INGATE PLACE SUBDIVISION, BLOCK 3, RESUBDIVISION OF LOTS 4, 5, & 6

Engineering Comments: FINAL PLAT COMMENTS (should be addressed prior to submitting the FINAL PLAT for review and/or signature by the City Engineer):

APPLICATION NUMBER 4 DATE December 7, 2017
 APPLICANT Ingate Place Subdivision, Block 3, Resubdivision of Lots 4, 5, & 6
 REQUEST Subdivision

DETAIL SITE PLAN

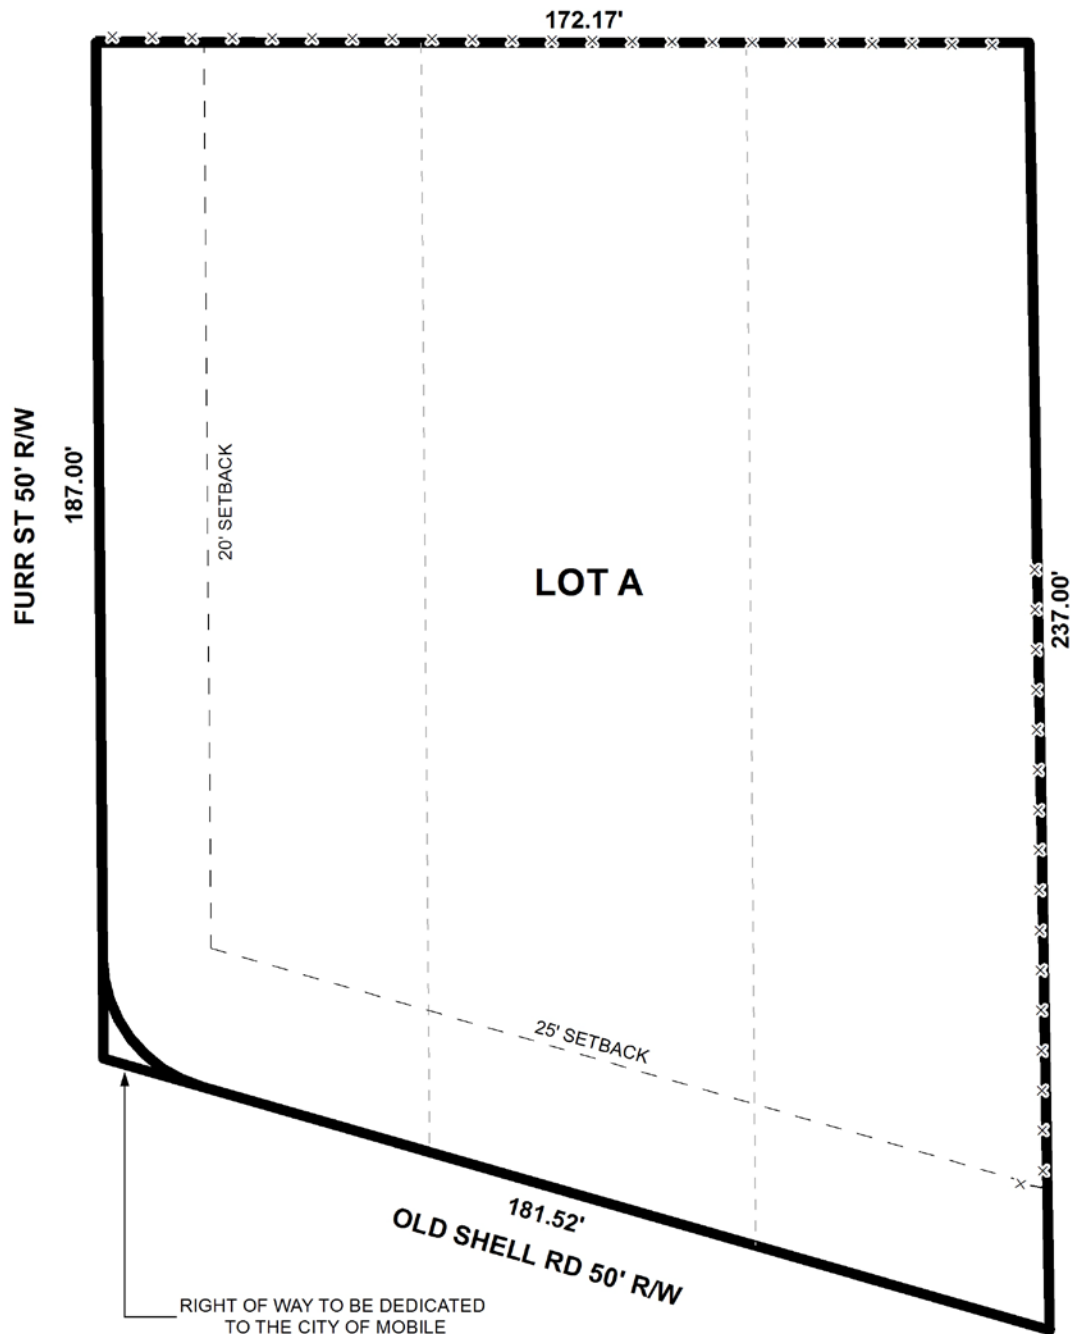
Dedication of the corner radius at the intersection of Old Shell Road and Furr Street is illustrated on the preliminary plat, as required by Section V.D.6. of the Subdivision Regulations, but it is

not labeled with the minimum 20' dedication requirement. As such, revision of the plat to indicate dedication of the corner radius is at least 20' should be required.

The 25' and 20' minimum building setback lines are illustrated along Old Shell Road and Furr Street, respectively, and should be retained on the Final Plat, if approved.

With regards to access management, a note should be placed on the Final Plat stating the lot is limited to one (1) curb cut to Old Shell Road and one (1) curb cut to Furr Street, with any changes in their sizes, locations, or designs to be approved by Traffic Engineering and conform to AASHTO standards.

- 1) revision of the plat to label dedication of the corner radius with the 20' minimum dedication requirement per Section V.D.6. of the Subdivision Regulations;

- 2) retention of the lot's size labeled in square feet and acres, or provision of table providing the same information;
- 3) retention of the 25' minimum building setback line along Old Shell Road;

- 4) retention of the 20' minimum building setback line along Furr Street;
- 5) placement of a note on the Final Plat stating the lot is limited to one (1) curb cut to Old Shell Road and one (1) curb cut to Furr Street, with any changes in their sizes, locations, or designs to be approved by Traffic Engineering and conform to AASHTO standards;
